MAYFLOWER PLATINUM

Details of Additions & Alterations

Flat No	303	Block no.	'A'
Flat Area	1500 sft	Type	Deluxe / Luxury
Buyer Name	Sridevi BN		
Phone No.	8309194357/9703314703	Email	Pavan 6655@gmail.com

ELECTRICAL PLAN OF FLAT-A3

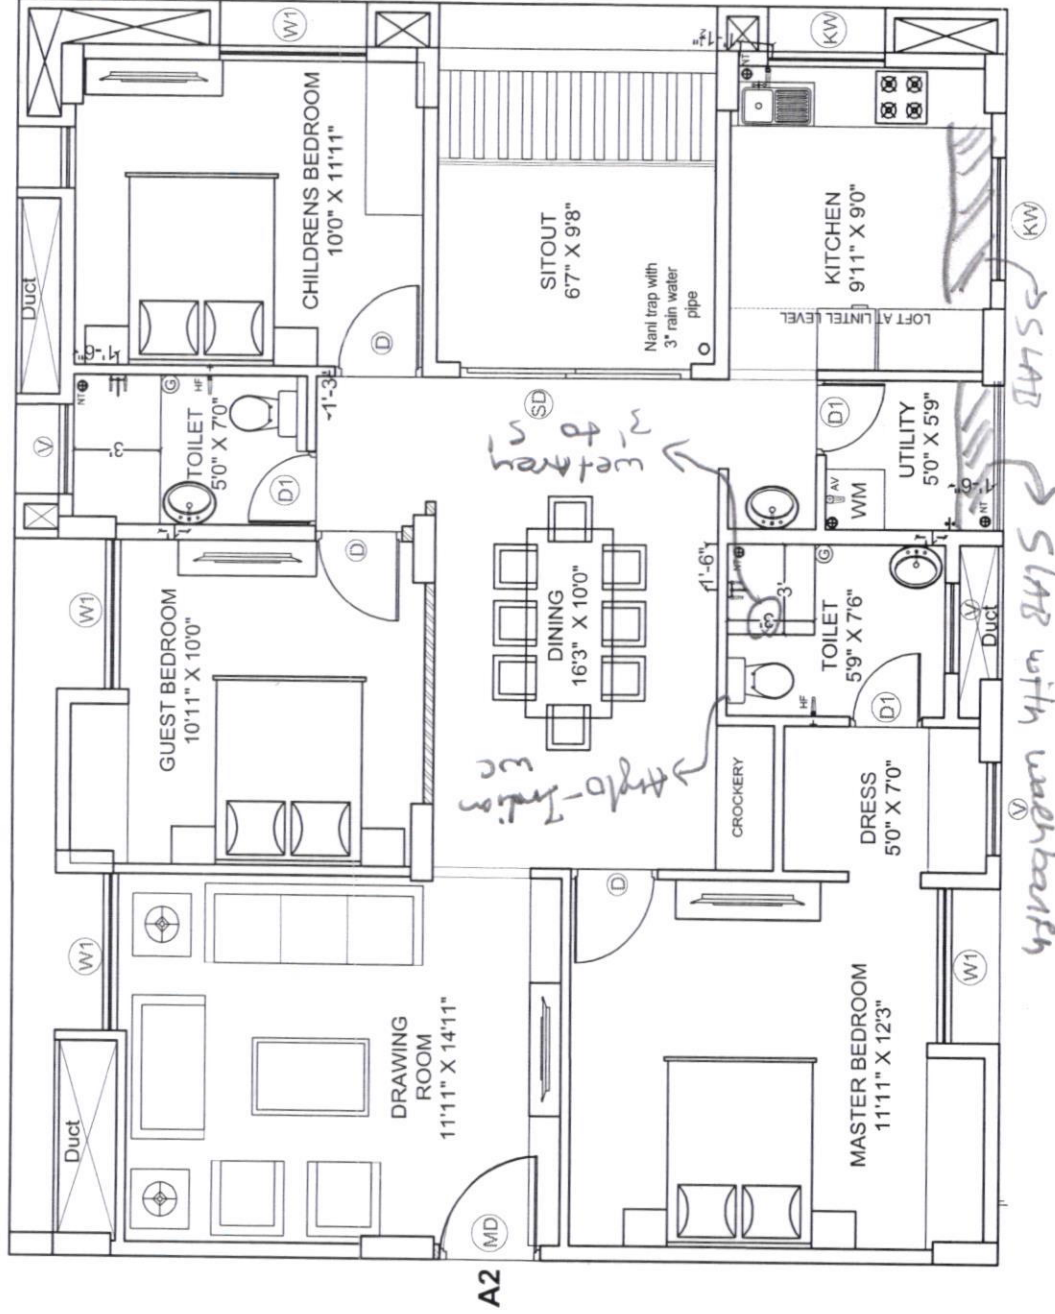
Changes in electrical points: (mark on plan)

Marked on Plan

PLUMBING PLAN OF A3	Description	Owners & Developers :	Date :	Promoted by
		Modi Properties Pvt. Ltd.	09.01.2020	Modi Properties &
		Project Name & Phase :	Prepared By :	Investments Pvt. Ltd.
		Mayflower Platinum	Approved By :	Phone:+91-40-66335551
			Scale :	N.T.S

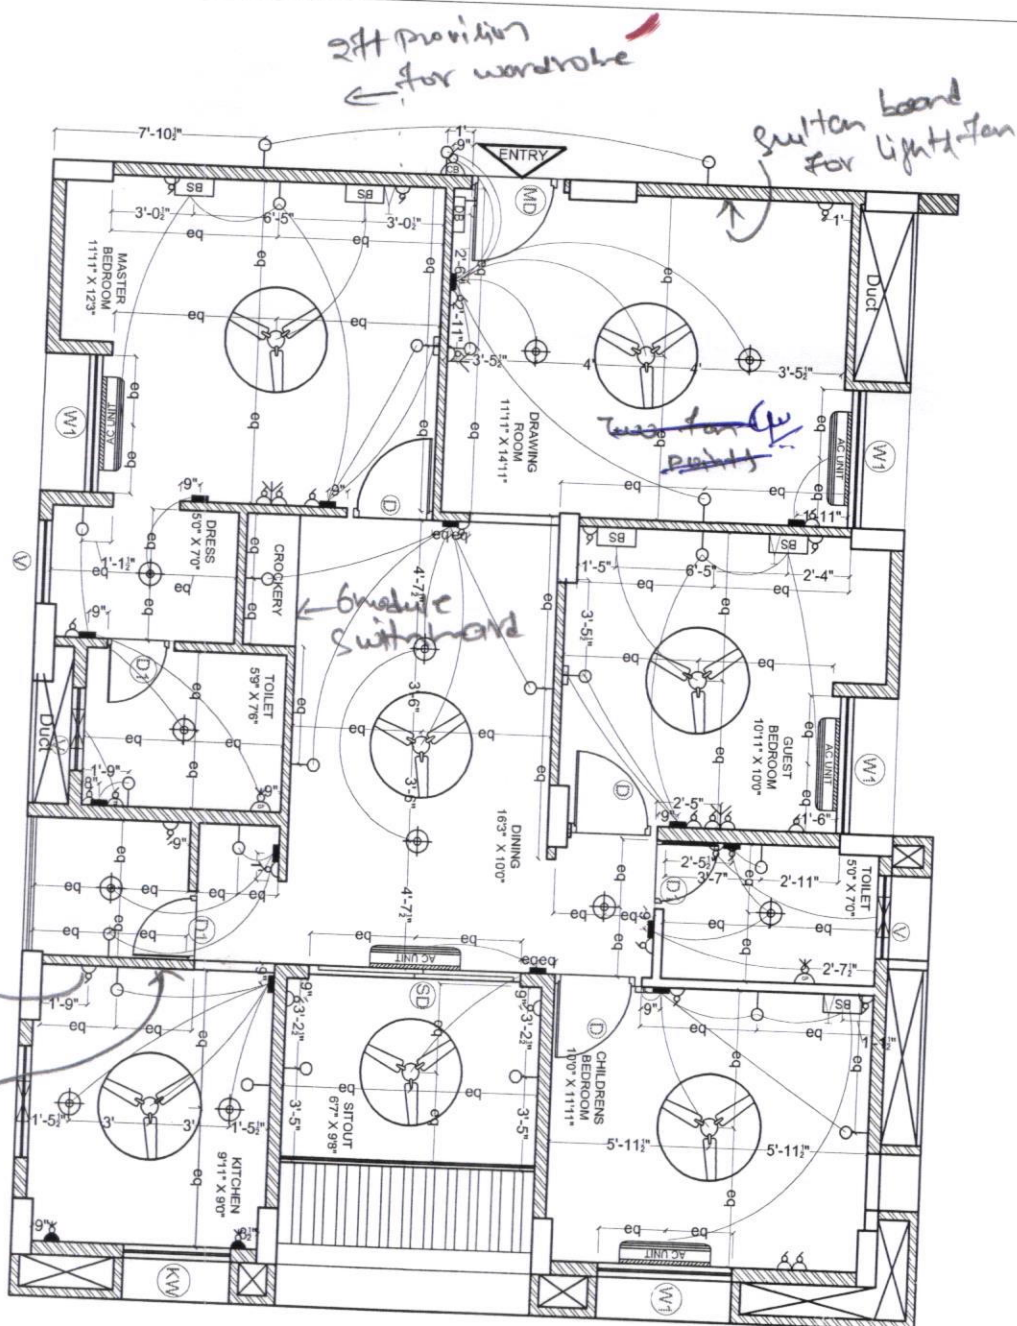
Choice of Bathroom tiles, CP fittings & Sanitary ware:

no changes in bathroom tiles & CP fittings
Anglo-Indian wc required in
Master bed room Toilet
